SUBDIVISION & UTILITY PLANS

HENRICO COUNTY, VIRGINIA

HICKORY WOODS AT TWIN HICKORY SECTION 2

LOT DIMENSION  
PLAN

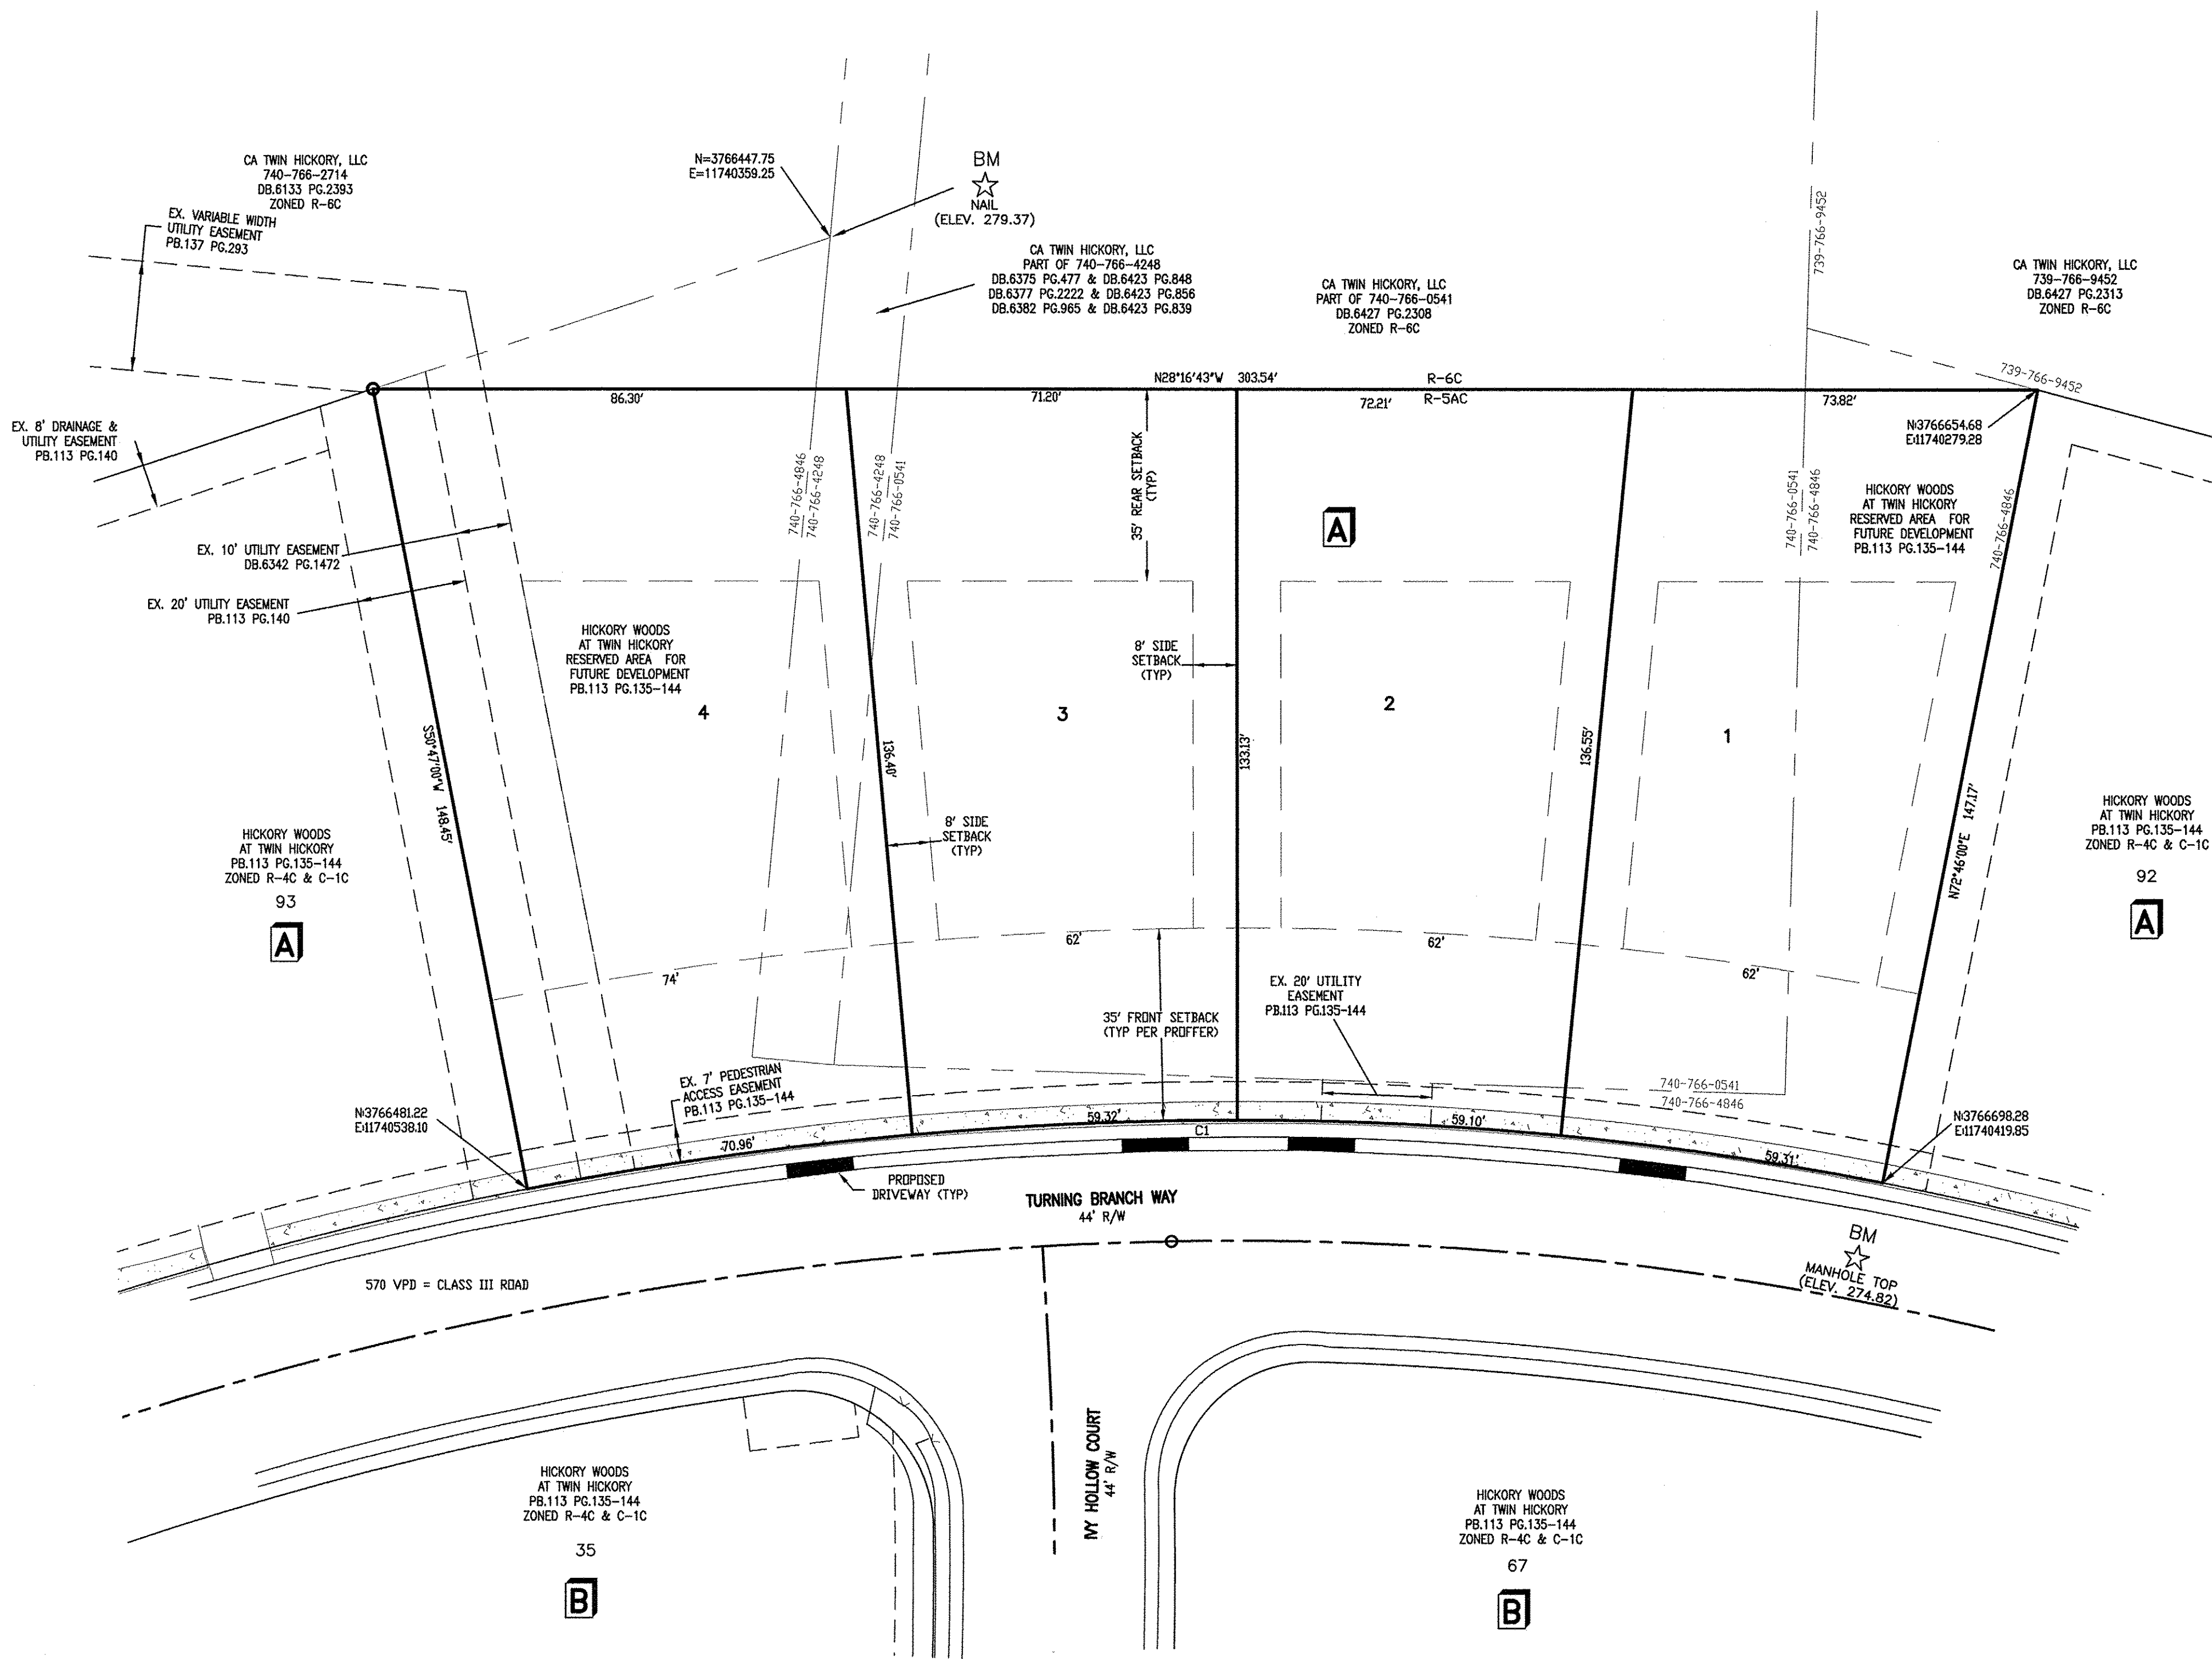
See mark ups on plat

**EROSION CONTROL PLAN (PH 1 & 2)**

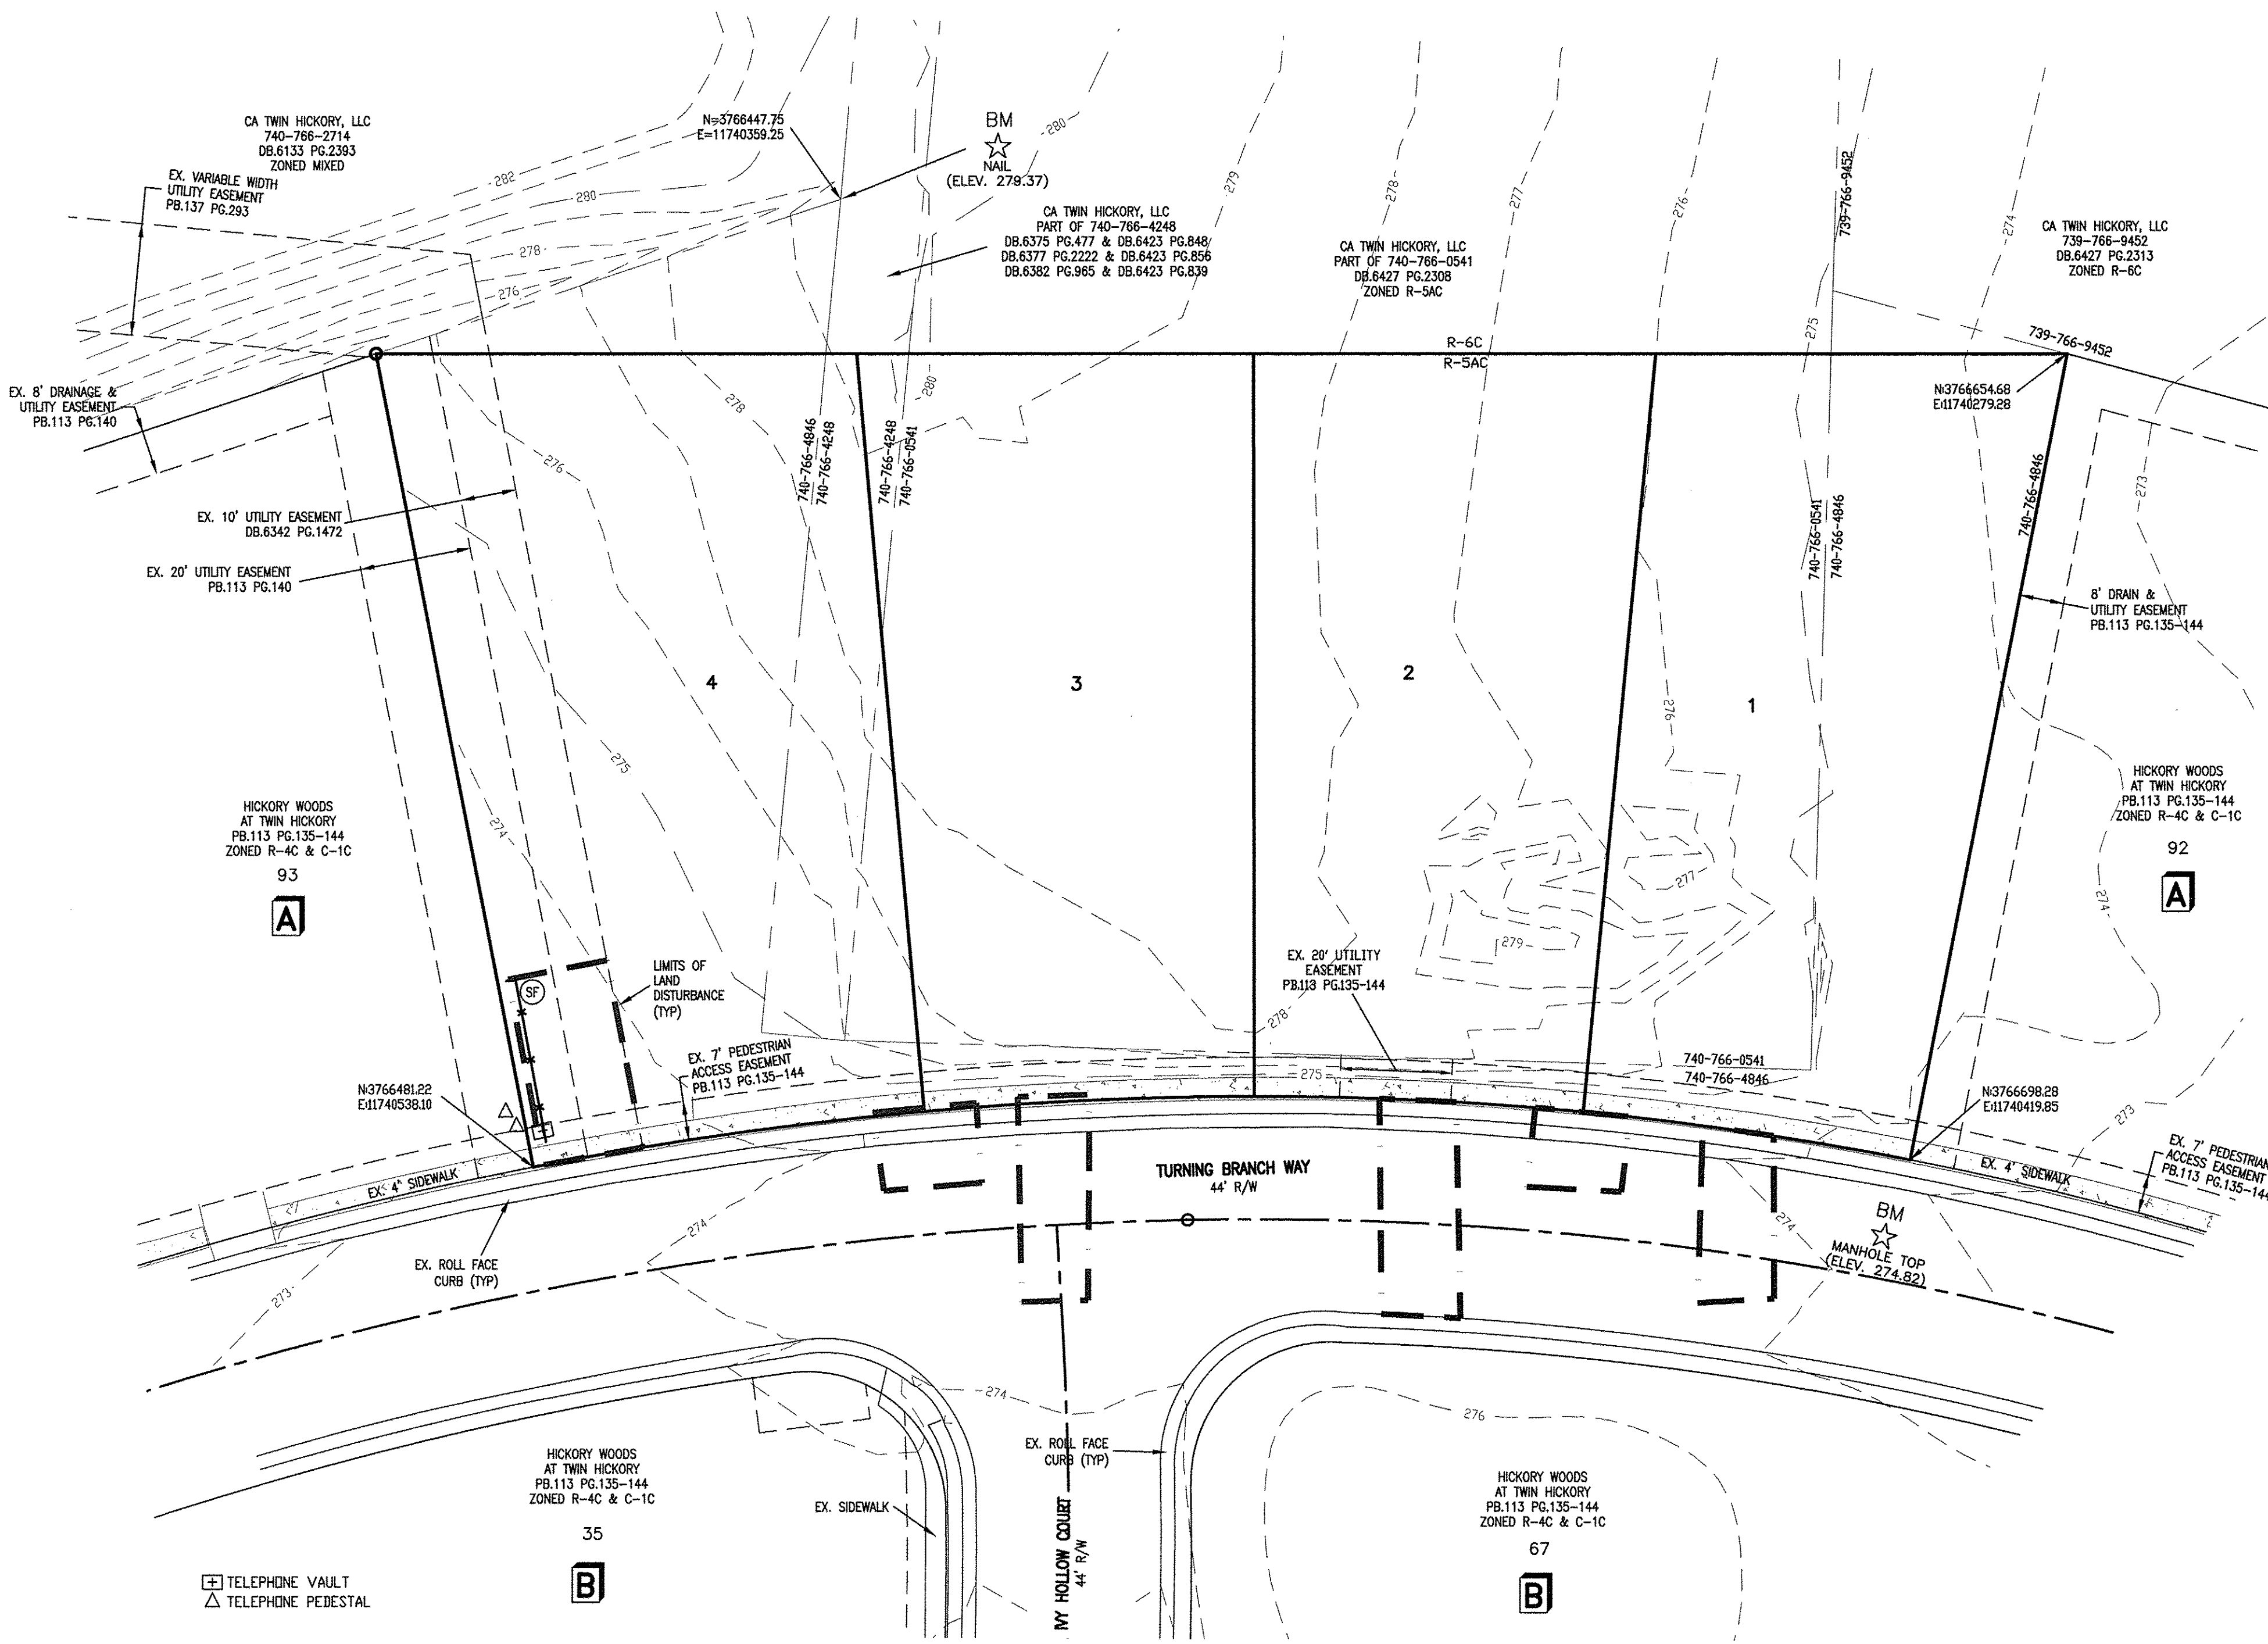
Hard copy has Tree Protection Plan

Need detail for Tree Protection tape.

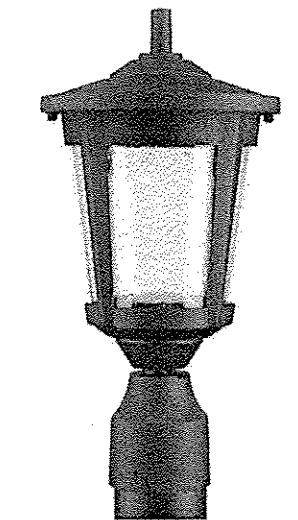
Provide averages  
0.5 to 2.0 averages required along pedestrian path
